May 30, 2023

Re: Landmark Square Building 3 ZB Application #223-12

As discussed, we offer the following responses and updated materials pursuant to our review of the application materials with you on 4/1423 and subsequent discussions with LUB and TTP staff on 5/23/23.

EXAMPLES OF BUILDINGS WITH GARAGE SCREENS

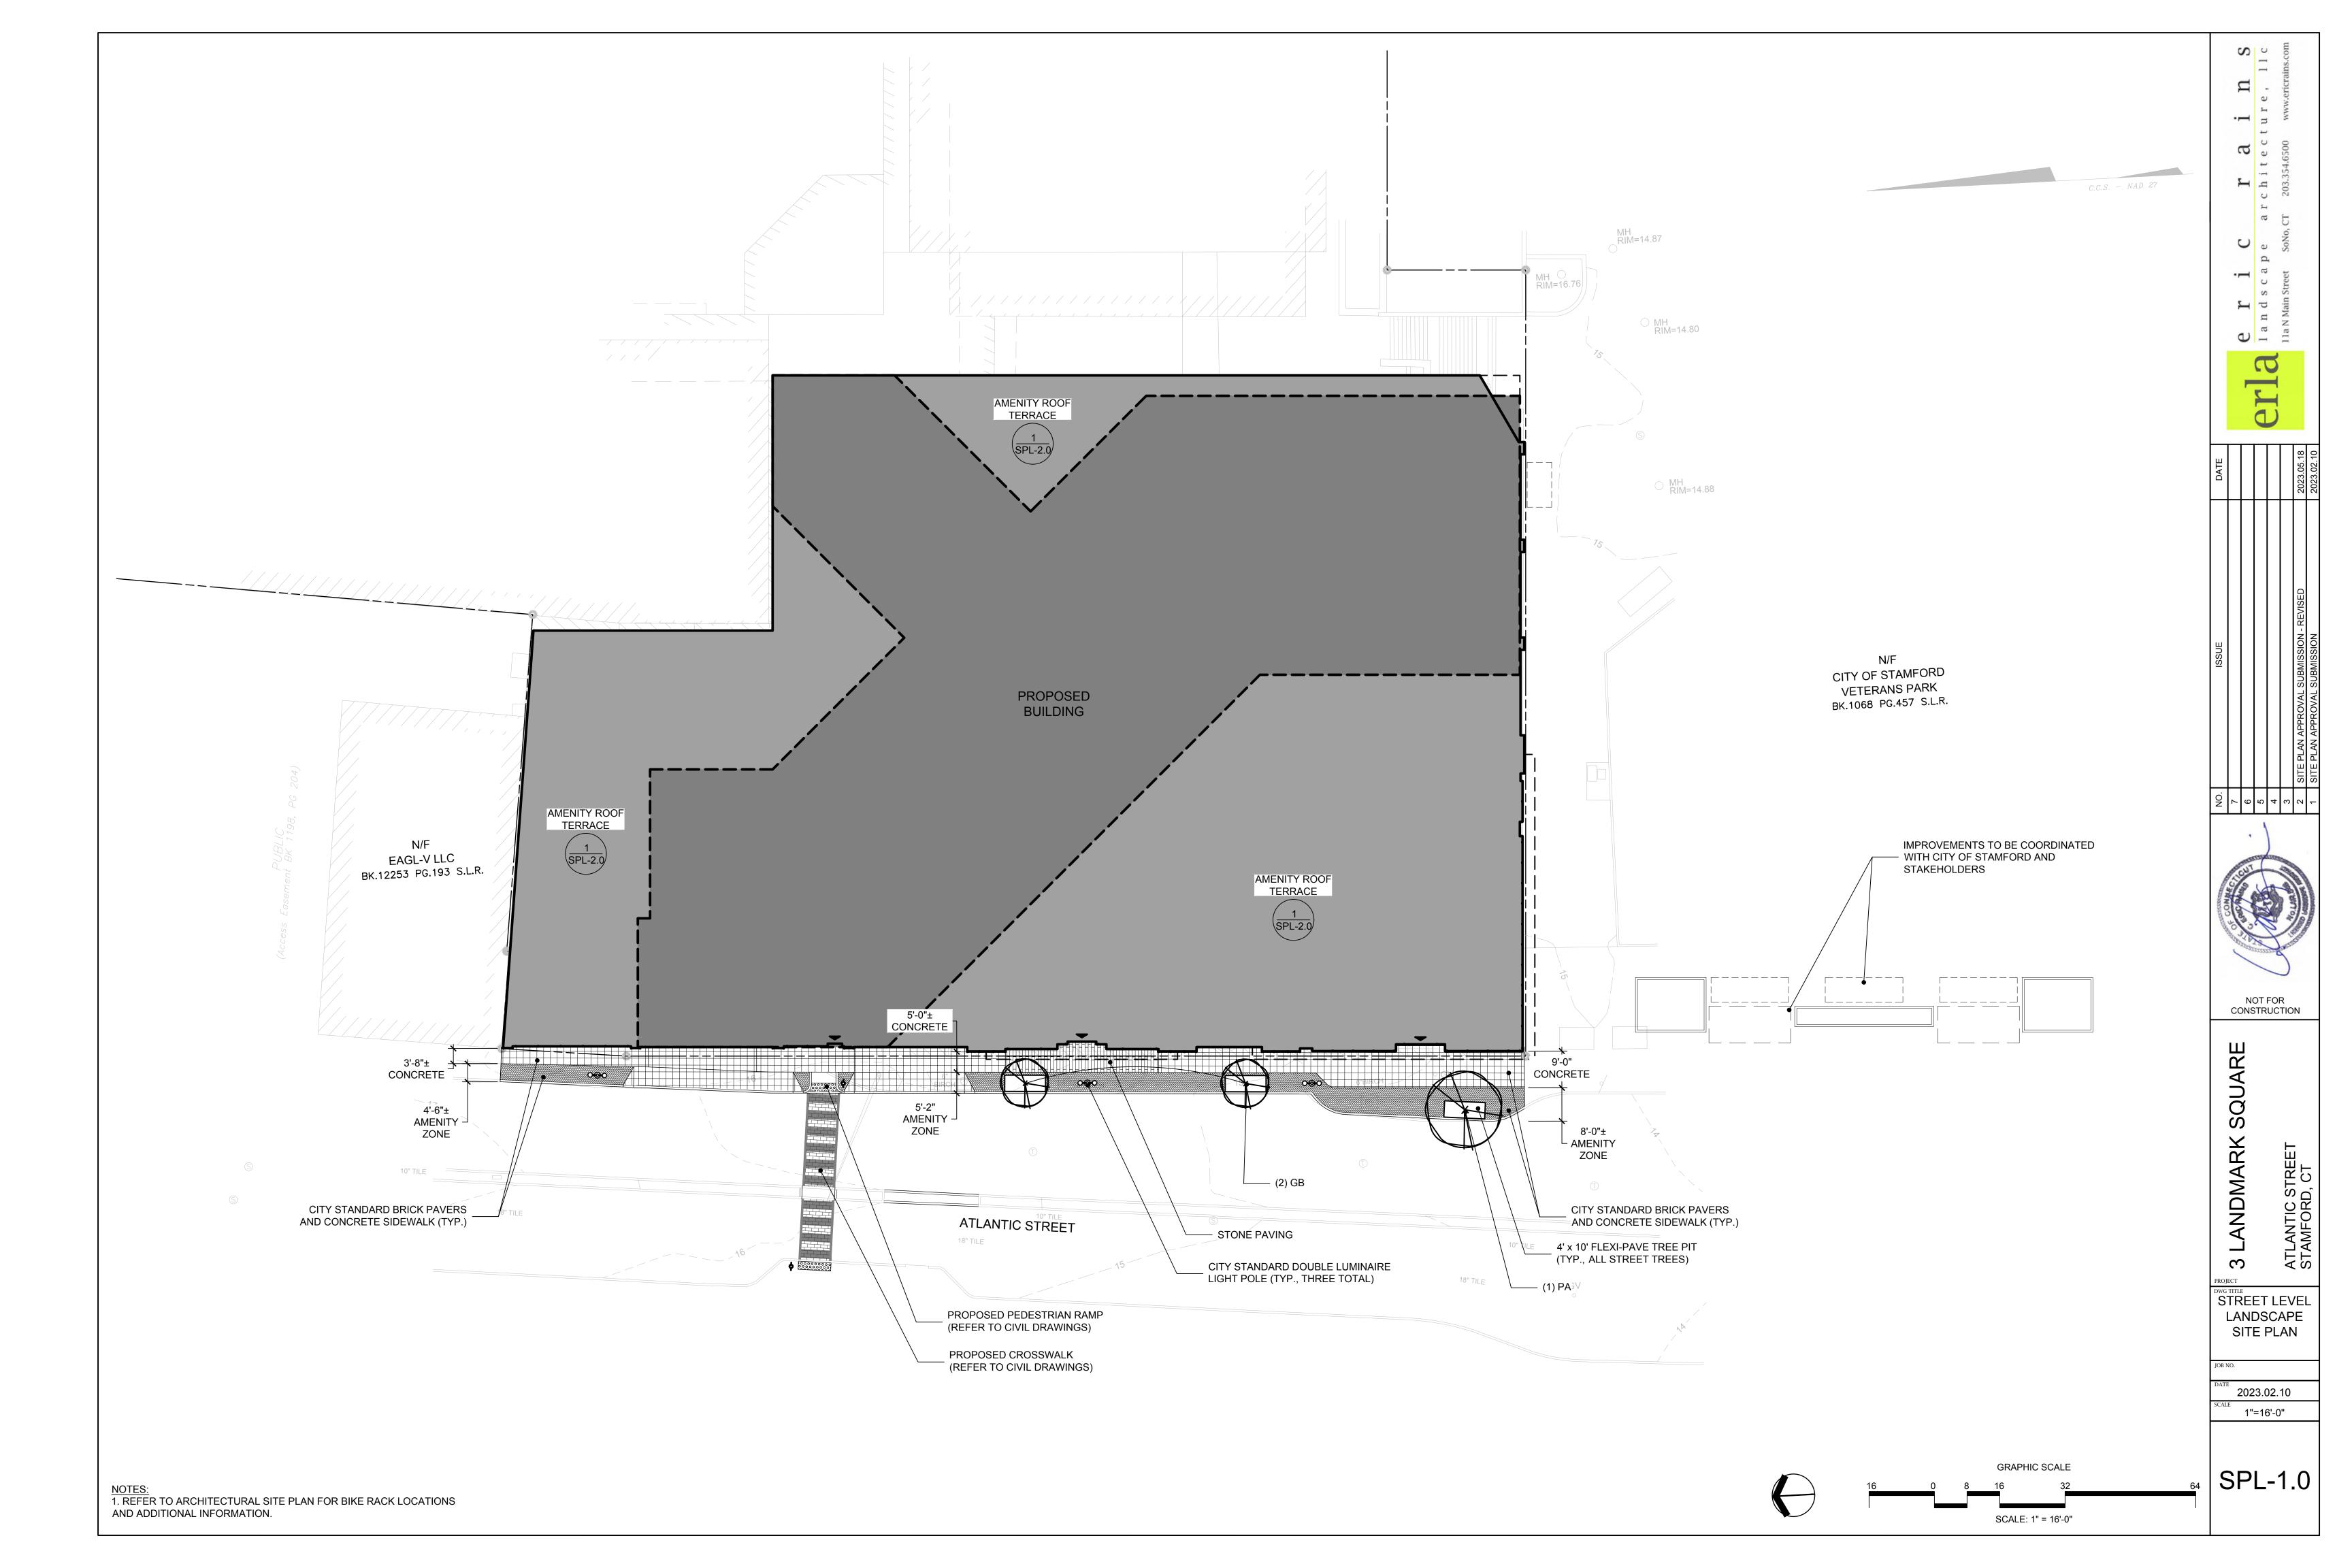
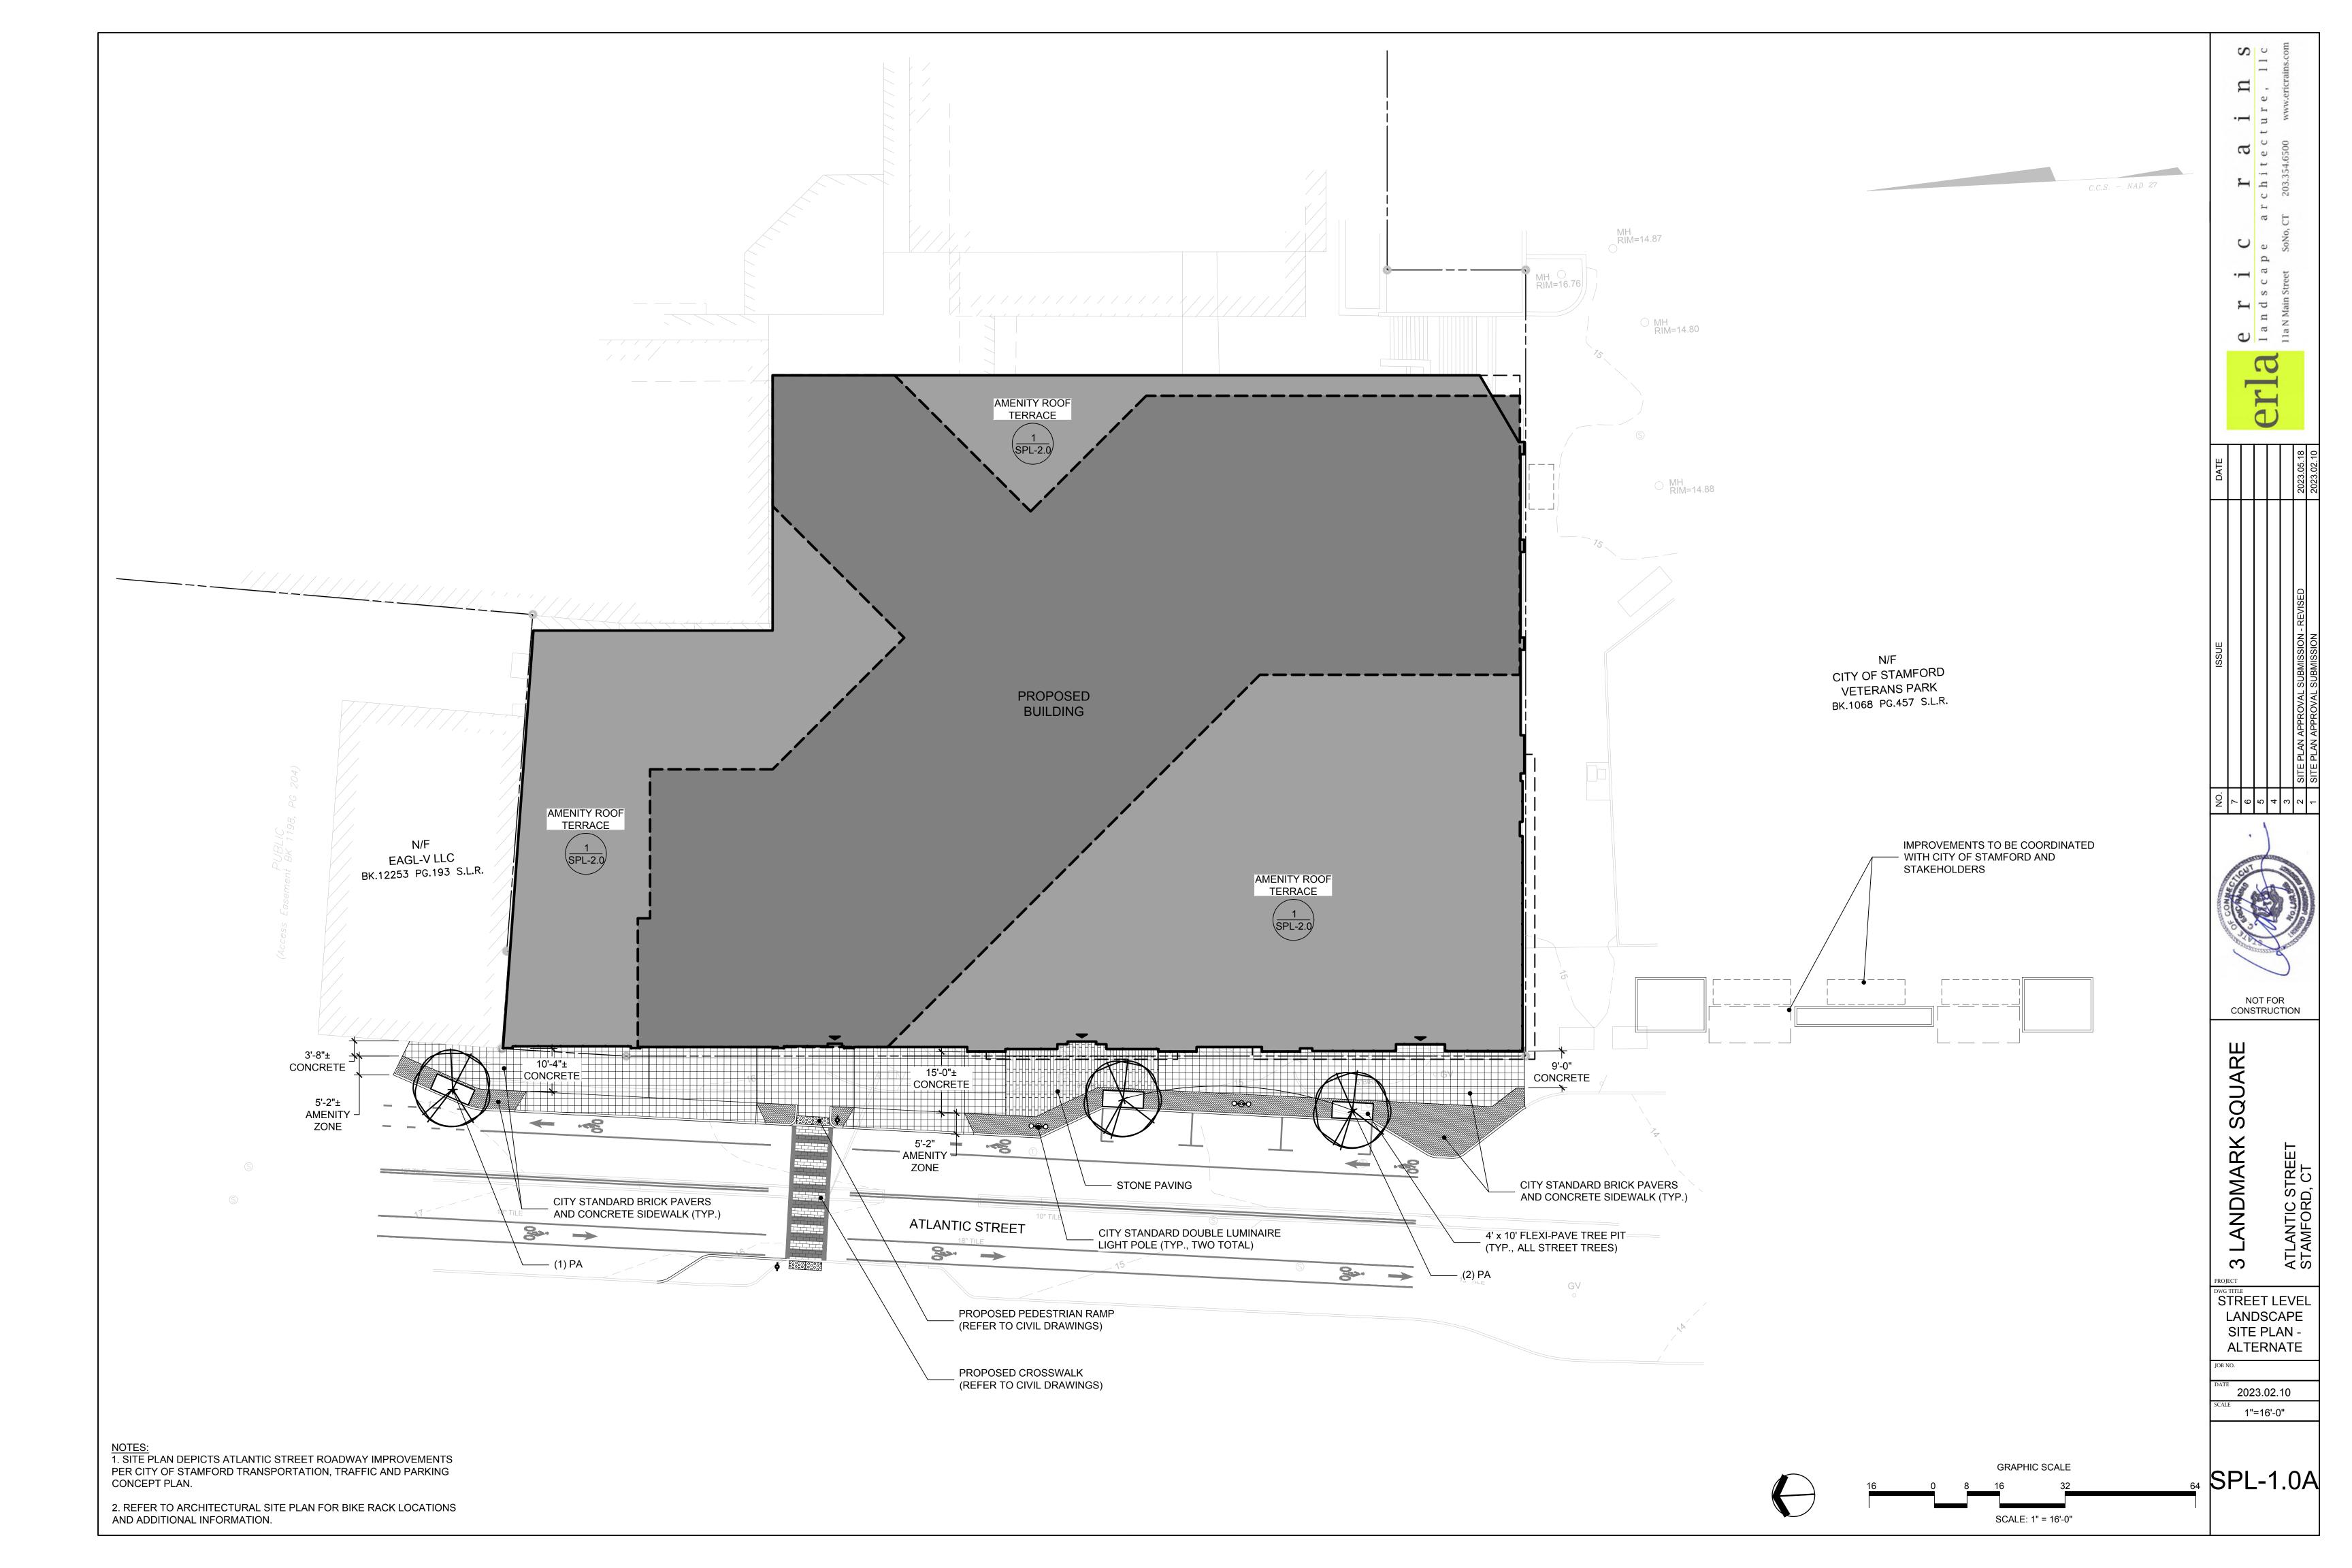
- i. the façade grid lines (which have been confirmed to have a 3" to 4" depth) and bay windows with a 2' depth.
 - ii. Metal panel garage screening which will be aluminum and not susceptible to rust. This type of screen is used on Atlantic Station and is available in a variety of finishes including flat, specular and gloss.
